Agency and Public Comments

RE: OPA 12 / ZBA-45

Re: Official Plan Amendment 12 and Zoning By-law Amendment 45
Address: 1555 18th Avenue East
Roll No: 425904006011000
City of Owen Sound
Applicant: Calloway

SUBJECT: ZBA - OPA ENGINEERING REVIEW 1555 18TH AVE EAST

Site Plan

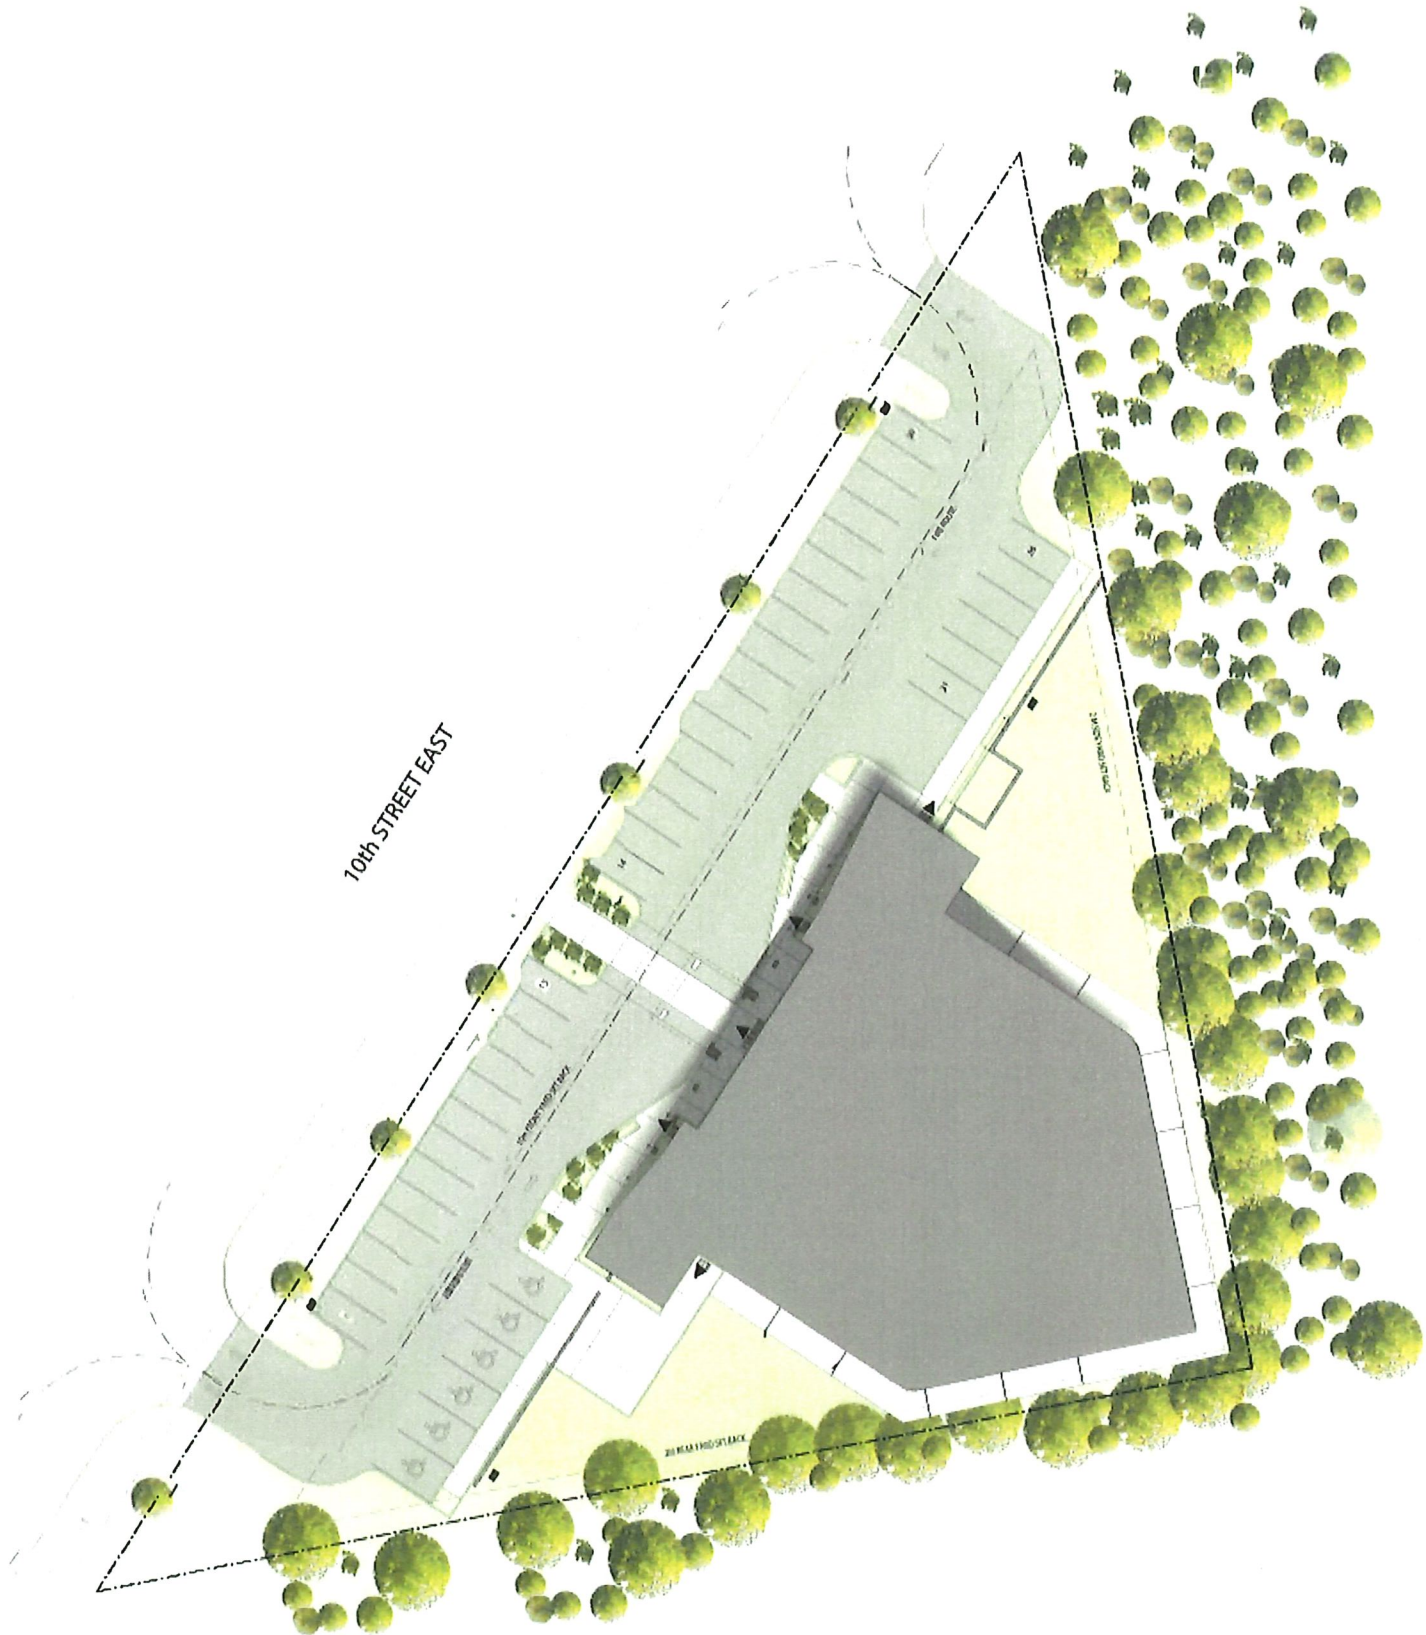
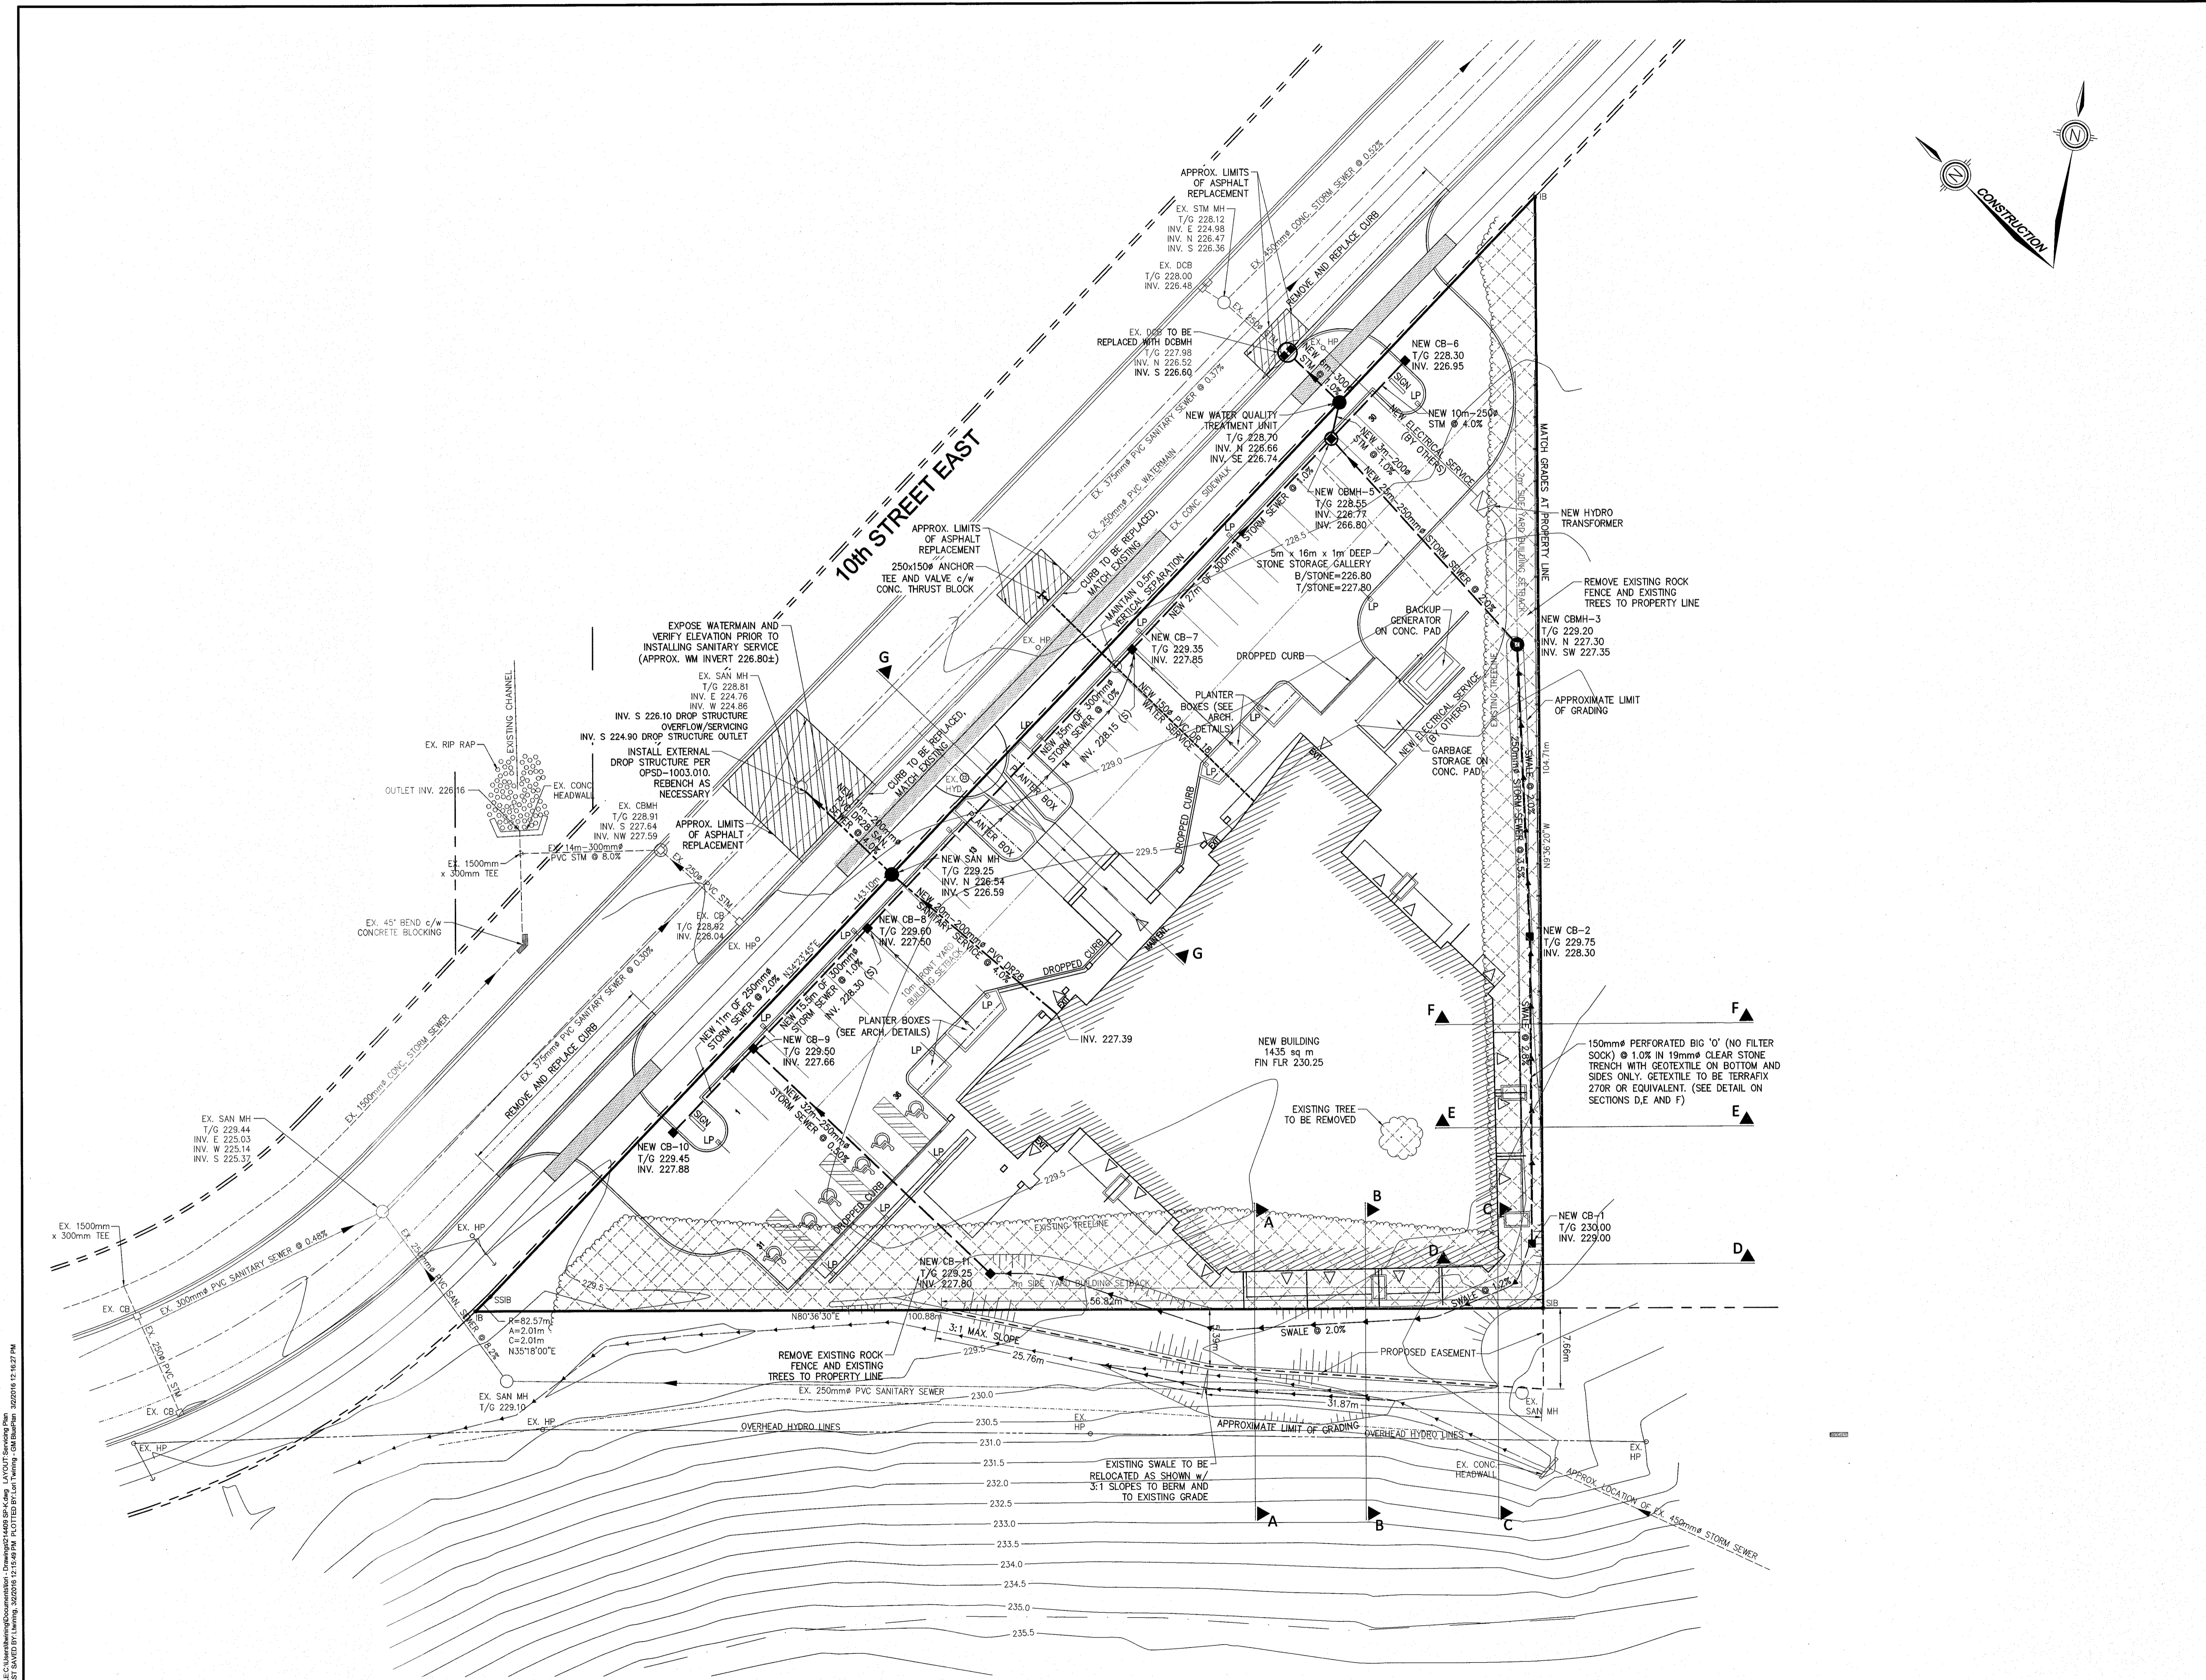
With a multi-level development “including apartment and cluster townhouse dwellings” as indicated in the Purpose and Effect of the received Notice, we are greatly concerned that a multi-storey building will loom over our yard and completely negate the privacy and respect that our residents currently enjoy. We would like to understand elements of the development such as where on the subject property the

buildings will be located, how high they will be, where parking lots will be located and where any “green space” might be placed. Our request of the developers is to work with us, and consider building a 6-foot berm, lined with trees on the abutting property line, that could assist with maintaining as much privacy and reduce direct sight lines as much as possible. This could help so that when our residents are outside, they are not readily seen from properties located in the subject area. A fence would also be requested on the developer’s property so that access is not possible through our yard. Our greatest fear is that the dignity, respect, and privacy that our residents and their families experience on our property will be compromised.

Our other concern is around water drainage on our property. There are 3 stormwater drains currently managing the flow very well. In our 5 years of operation, we have never had any drainage problems, nor have we experienced any water issues in our building. We would like to understand the stormwater and drainage plans of the developer and how that might impact our property, particularly as there appears to be slope to the land as it currently exists, with Chapman House being at the low point of the area.
